REVIEW COMMENTS ON THE PHASE II
REMEDIAL INVESTIGATION SAMPLING PLAN

U.S. DEPARTMENT OF ENERGY
ROCKY FLATS PLANT

TETRA TECH, INC.
FOR
JACOBS ENGINEERING GROUP, INC.
PROJECT NUMBER: 05-8524-00
TC-3621-09

OCTOBER 1988

Figure 1 Existing and DOE proposed alluvial monitoring wells at 903 Pad Mound and East Trenches area

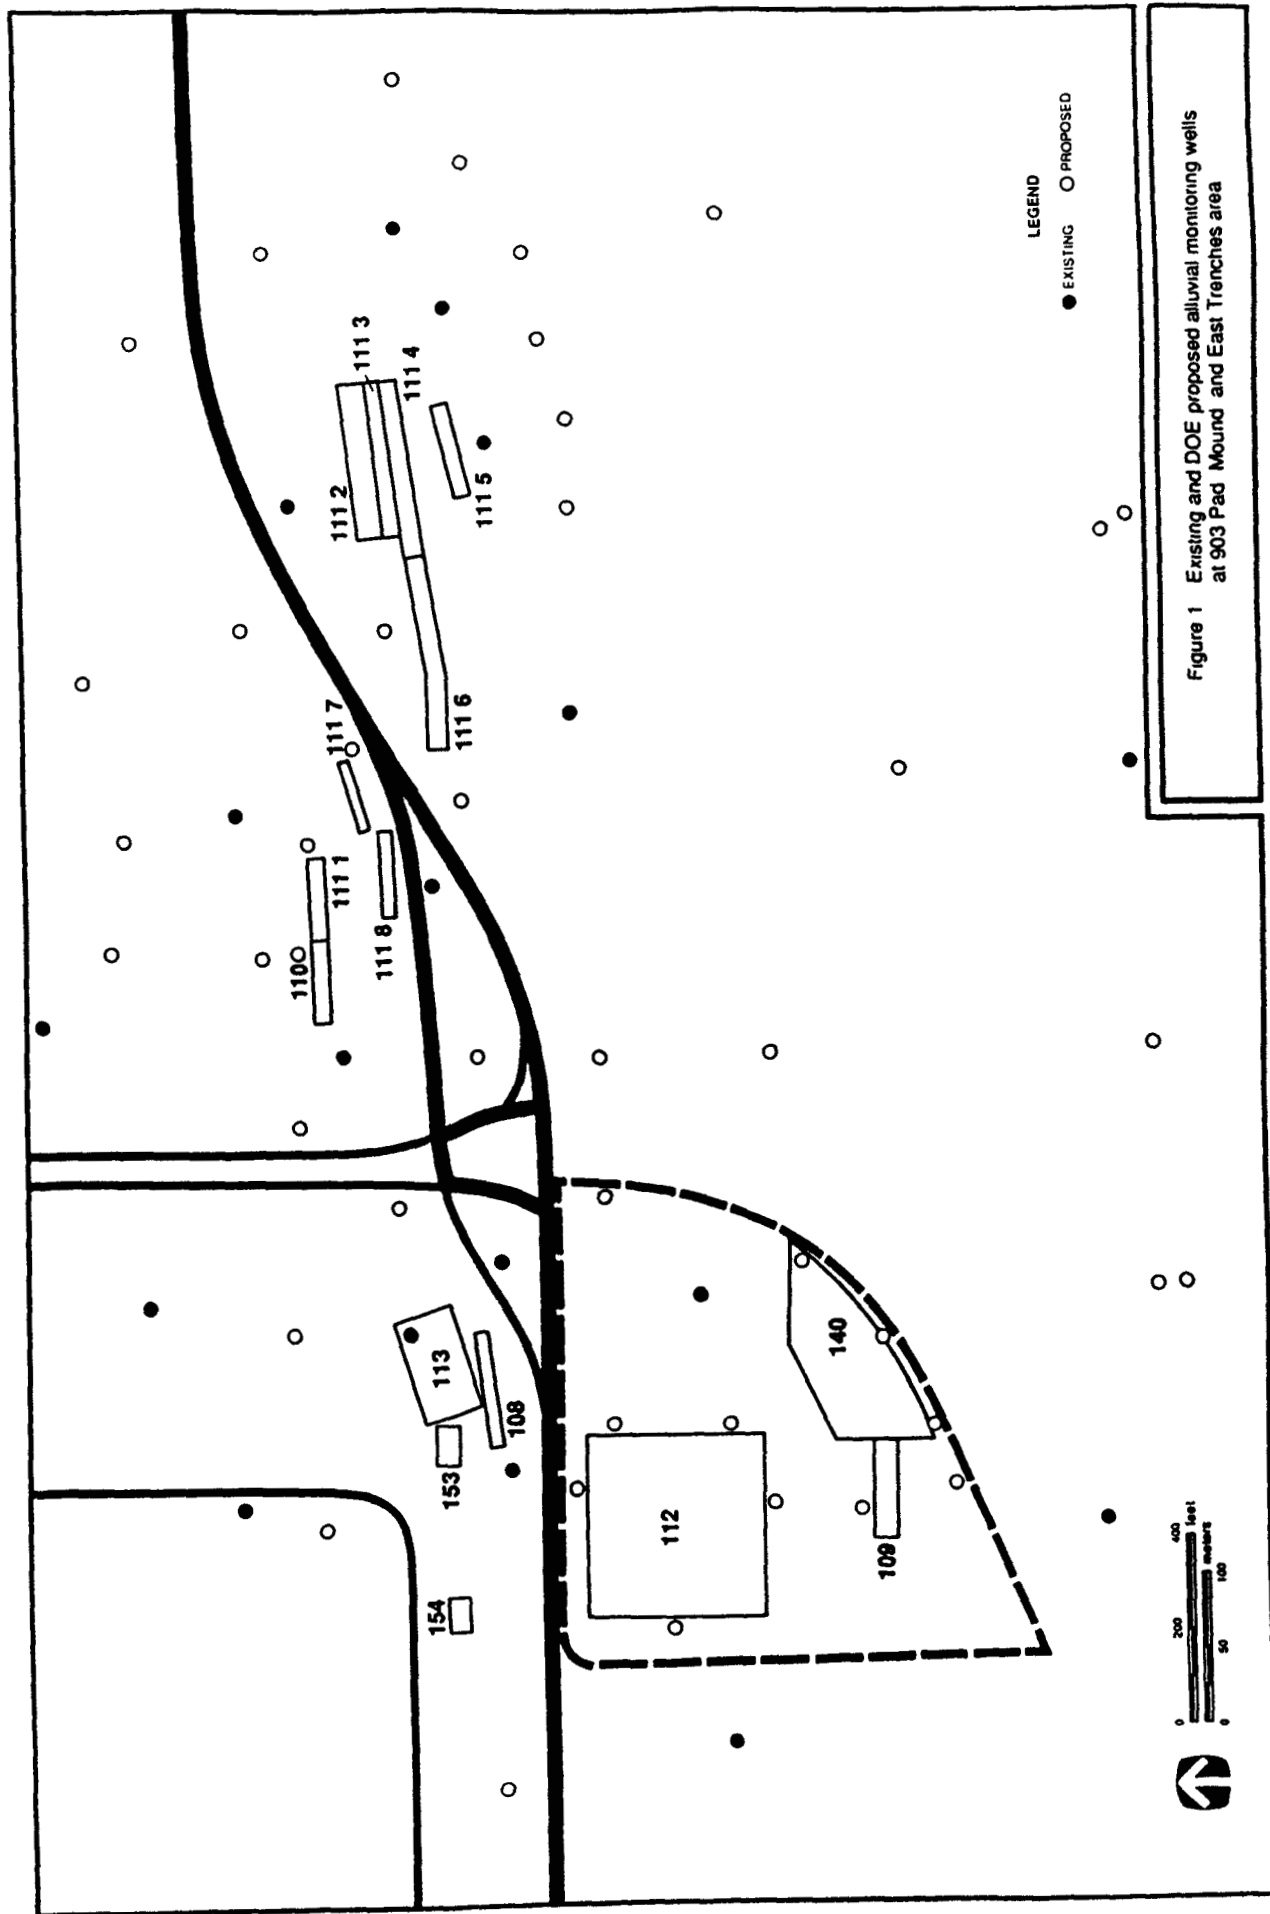
The Phase II RI plan proposes 49 additional wells to monitor the alluvial aquifer in the 903 Pad, Mound, and East Trenches areas (Figure 1). The discussion below focuses on the proposed locations of the monitoring wells, and on recommendations concerning changes and additions to the proposed well installations. Potential problems concerning screen placement and well construction materials were addressed in the previous section. Unless specifically mentioned below, the proposed well locations in the Phase II RI plan are acceptable for Phase II of the RI.

It is recommended that several of the proposed alluvial monitoring wells be relocated to provide better data for source characterization and plume definition, in addition to providing usable potentiometric data for the site (Figure 2). The recommended relocations and rationale for each move are described as follows:

- Well 8-88 -- Move 175 ft west. The new location will provide water quality data immediately downgradient of the 903 Pad area.
- Well 45-88 -- Move approximately 150 ft south. The new location is closer to potential sources in the East Trenches area, and will provide data on the nature of contaminants being discharged from these SWMUs. The original location was more than 450 ft downgradient of Well 35-87, the well closest to Trench T-4 (too large of a gap).
- Well 52-88 -- Move 75 ft southwest (near borehole 46-87). The new location will provide downgradient water quality information for Trench T-11. The proposed location appears to be cross-gradient to the trench.
- Well 43-88 -- Move 150 ft southwest and install a well cluster at this location (see below). The recommended location is closer to Trenches T-3 and T-4, and is centrally located between Wells 79-88 and 36-86.

The majority of alluvial wells proposed in the Phase II RI plan are located to provide adequate plume definition data. While this is necessary and will serve to meet nature and extent DQOs, additional source characterization data are needed to begin meaningful technology screening for the FS. As previously discussed, if boreholes and monitoring wells cannot (or will not) be installed in the source areas themselves (e.g., through the trenches), then wells immediately adjacent to, and downgradient from, the sources must be installed.

- Well A-88 -- Located 300 ft south-southwest of Well 31-88, this alluvial well will help fill a substantial gap downgradient of the 903 Pad area (see Figure 1). Currently, there are no existing or proposed alluvial wells downgradient of Wells 14-88 and 15-88 for at least 900 ft.

- Well B-88 -- Located 250 ft due east of Well 14-88. This well will help fill a substantial gap downgradient of the 903 Pad area (see Figure 1). Currently, there are no existing or proposed alluvial wells downgradient of Wells 14-88 and 15-88 for at least 900 ft.

Figure 2 Tetra Tech recommended additions and changes to monitoring well program for the Phase II RI

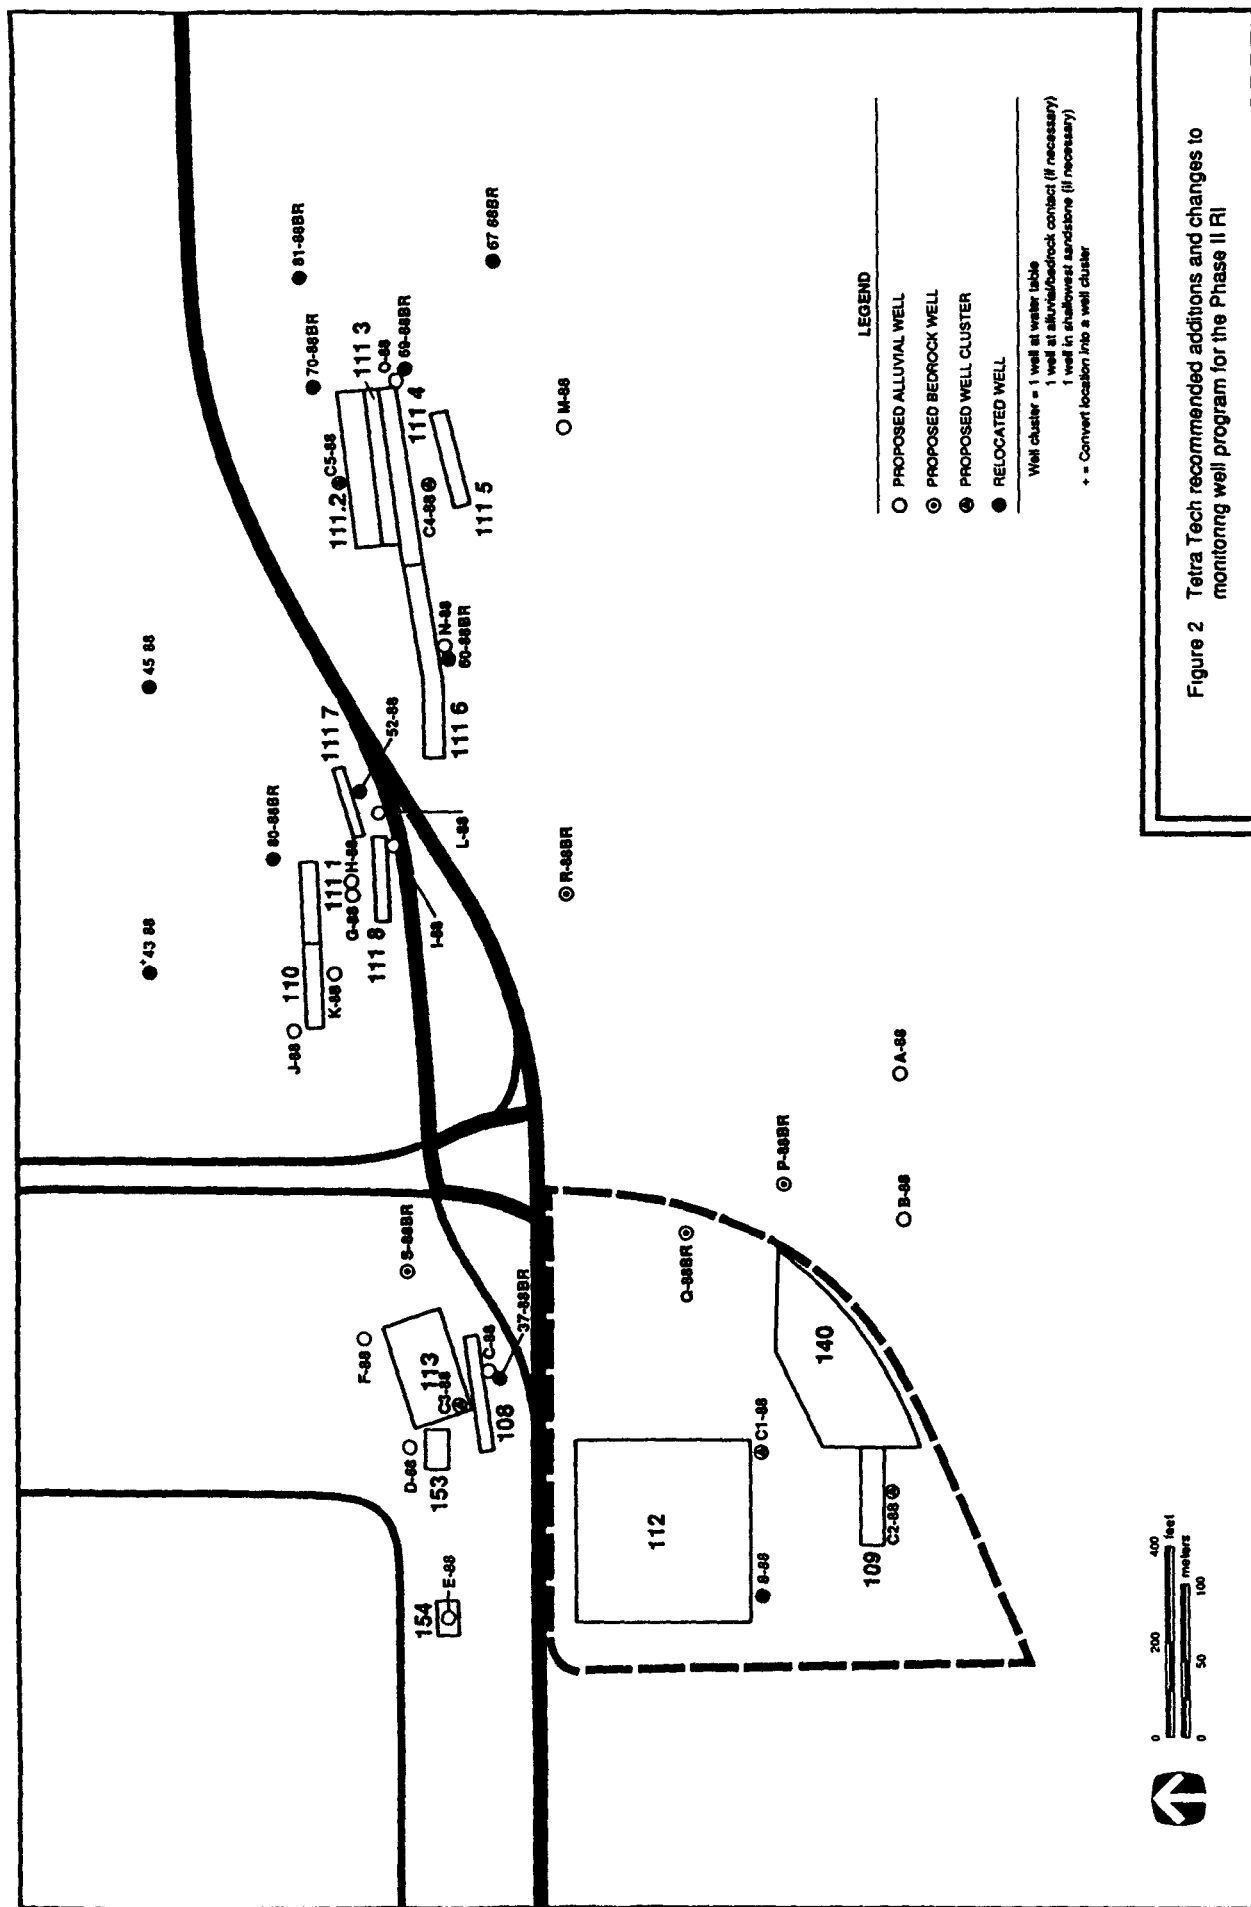
The following paragraphs discuss recommended additions to the alluvial monitoring system. In general, these additions focus on acquiring source data as well as obtaining vertical hydraulic gradient data that are crucial for evaluating contaminant transport. The recommendations below are based on hydrogeologic data and sampling results provided in the Phase I RI report (Rockwell International 1987), and in the Phase II RI plan. If information not contained in these documents has a bearing on the recommendations, then it should be provided, referenced, and alternative approaches presented.

Well clusters are proposed at several strategic locations. The well clusters will provide information needed to define contaminant levels near sources, and critical hydrogeologic data. The proposed clusters are comprised of up to three separate wells located in close proximity to each other (e.g., within 10-15 ft). It is recommended that one of the wells in the cluster be screened at the water table in the alluvium, the second well screened at the alluvium/bedrock contact (i.e., in the weathered bedrock), and the third well screened in the sandstone bed encountered below the alluvium/bedrock contact. Specific sandstone layers that should be monitored are recommended below. The wells should be oriented so that the alluvial well is closest to SWMU, with the alluvium/bedrock contact well located downgradient of the alluvial well, and the bedrock well located just downgradient of the alluvium/bedrock contact well. This arrangement follows likely contaminant migration pathways, and will minimize the influence of the grout and seals used to construct deep wells on the water quality in nearby shallower wells, while providing data on vertical hydraulic gradients between and within formations. If the weathered bedrock zone is thin (less than 5 ft), then one screened interval could be used to monitor both the weathered bedrock and the sandstone zones. Similarly, if the water table and the alluvium/bedrock contact are close to each other (within 5-10 ft), then a single screen could be used to cover both zones.

Recommended additions and associated rationale for the placement of monitoring wells or clusters (see Figure 2) are as follows:

- Cluster C1-88 -- A well cluster should be located immediately adjacent to, and 50 ft west of, the southeast corner of the 903 Pad area. This cluster location is downgradient of the center of the 903 Pad area and will provide critical hydrogeologic and source characterization data. The bedrock well should be completed in sandstone X or Y.

- Cluster C2-88 -- This cluster, located next to Borehole 25-87, will establish the downgradient groundwater quality immediately adjacent to Trench T-2. Currently, the nearest existing, or proposed downgradient well is 125 ft away (Well 12-88). This cluster will help to establish the extent to which vertical migration occurs at the source. The bedrock well should be completed in sandstone X or Y.

- Cluster C3-88 -- Located 100-200 ft west of Borehole 36-87. This cluster should be installed within the Mound area (SWMU 113, see Well 19-87) to provide source characterization and vertical migration data. There are no existing or proposed wells presently located in this area. The perimeter security fence and some buried utilities are located in this area. A review of as-built drawings, and a geophysical survey may be required to locate buried utilities or other structures prior to drilling. The bedrock well should be completed in sandstone X.

- Well C-88 -- Located next to Well 37-88BR (also proposed for relocation) to monitor alluvial groundwater quality downgradient of Trench T-1 and the Mound area. Currently, there are no proposed alluvial wells in this area. By locating this well next to Well 37-88BR, information on vertical hydraulic gradients can be obtained.

- Well D-88 -- Located just north and downgradient of the oil burn pit (SWMU 153). Currently, no wells are located downgradient of this probable contaminant source area.

- Well E-88 -- Located in SWMU 154 (pallet burn site). This well will provide source characterization data for this SWMU, and help complete potentiometric maps for the alluvial groundwater system.

- Well F-88 -- Located 50 ft north of Borehole 20-87BR. This well will provide water quality data immediately downgradient of the Mound area.

- Wells G-88 and H-88 -- These two wells should be located next to 47-88BR, converting this location to a three (or two) well cluster. One well should be screened at the water table, and the other at the alluvium/bedrock contact. This cluster will provide source characterization and vertical migration data for Trenches T-4 and T-11.

- Well I-88 -- This well will be located 25 ft west of the southeast corner of Trench T-10 to monitor downgradient water quality. Currently, no wells are located to the south (downgradient) of Trench T-10.

- Well J-88 -- Located halfway between Well 40-88 and Well 46-88. This well will provide alluvial groundwater quality data immediately north of SWMU 110 (Trench T-3).

- Well K-88 -- Located 50 ft east of Borehole 39-87. This well will provide alluvial groundwater quality data south of SWMU 110 (Trench T-3), and provide important potentiometric data in this area.

- Well L-88 -- Located 25 ft southwest of Borehole 46-87. This well will provide alluvial groundwater quality data south of SWMU 111.7 (Trench T-10).
- Well M-88 -- Located next to alluvial Well 65-88 and bedrock Well 64-88BR. Well M-88 should be completed at the alluvium/bedrock contact, assuming that Well 65-88 will be completed at the water table in the alluvial aquifer.

- Well O-88 -- This well will be located next to Well 69-88BR (also proposed for relocation). In conjunction with Well 69-88BR, Well O-88 will monitor alluvial groundwater quality downgradient of Trenches T-5, T-6, and T-7 (SWMUs 111.2-111.4), and provide vertical gradient information.
- Cluster C4-88 -- This cluster will be located 50 ft east of Borehole 52-87, directly downgradient of Trenches T-5, T-6, and T-7. There are currently no existing or proposed wells in this area. The bedrock well should be completed in sandstone P.
- Cluster C5-88 -- This cluster will be located next to Borehole 55-87 to determine if contaminants detected in the soils at this location have reached the groundwater north of Trench T-5. The bedrock well should be completed in sandstone P.

The following is a list of proposed bedrock wells (see Figure 2) recommended for relocation together with the rationale for relocation:

- Well 37-88BR -- Move approximately 50 ft north. This well should be adjacent to Trench T-1 and a proposed alluvial well. This new location will provide source characterization downgradient of Trench T-1. The original location appears to be too far downgradient of Trench T-1 to provide adequate data on bedrock contamination in the vicinity of Trench T-1.

- Well 80-88BR -- Move 200 ft southwest. This new location will provide better areal distribution of wells completed in sandstone R, and provide downgradient water quality data for Trench T-4. The original location is too far downgradient (250 ft) of Trench T-4, and too close to Well 36-87BR.

- Well 60-88BR -- Move approximately 50 ft north. The new location is adjacent to Trench T-9 and a proposed alluvial well. This new location will provide downgradient water quality data for Trench T-9. The original location appears to be too far downgradient of Trench T-9, and may have been placed south of the paleochannel, which may influence contaminant migration.

- Well 69-88BR -- Move approximately 100 ft northwest. The new location is adjacent to the southeast corner of Trench T-7,

- Well 67-88BR -- Move 100 ft south. This new location will provide a better areal distribution of wells completed in sandstone P and help define the contaminant plume in this sandstone. The original location is too close to proposed Well 68-88BR, which monitors the next deepest sandstone (sandstone N).
- Well 81-88BR -- Move 200 ft north. This new location will monitor downgradient groundwater quality in sandstone M (near the northeast corner of Trench T-5), and provide a better areal distribution of wells in this area. The original location is too close to Well 40-86BR.
- Well 70-88BR -- Move 300 ft northwest. This new location will monitor downgradient groundwater quality in sandstone O (near Trench T-5), and provide a better areal distribution of wells in this area. The original location is too close to Well 40-86, which monitors the next deepest sandstone (sandstone P).

- Well P-88BR -- Located 100 ft east of the northeast corner of the reactive metal destruction site. This bedrock monitoring well should be completed in sandstone V or W.
- Well Q-88BR -- Located 150 ft southeast of existing Well 16-87BR. This bedrock monitoring well should be completed in sandstone X or Y.

- Well R-88BR -- Located exactly halfway between proposed Well 33-88 and proposed Well 51-88. This bedrock monitoring well should be completed in sandstone R or S.
- Well S-88BR -- Located 100 ft northeast of the southeast corner of the Mound. This bedrock monitoring well should be completed in sandstone X or Y.
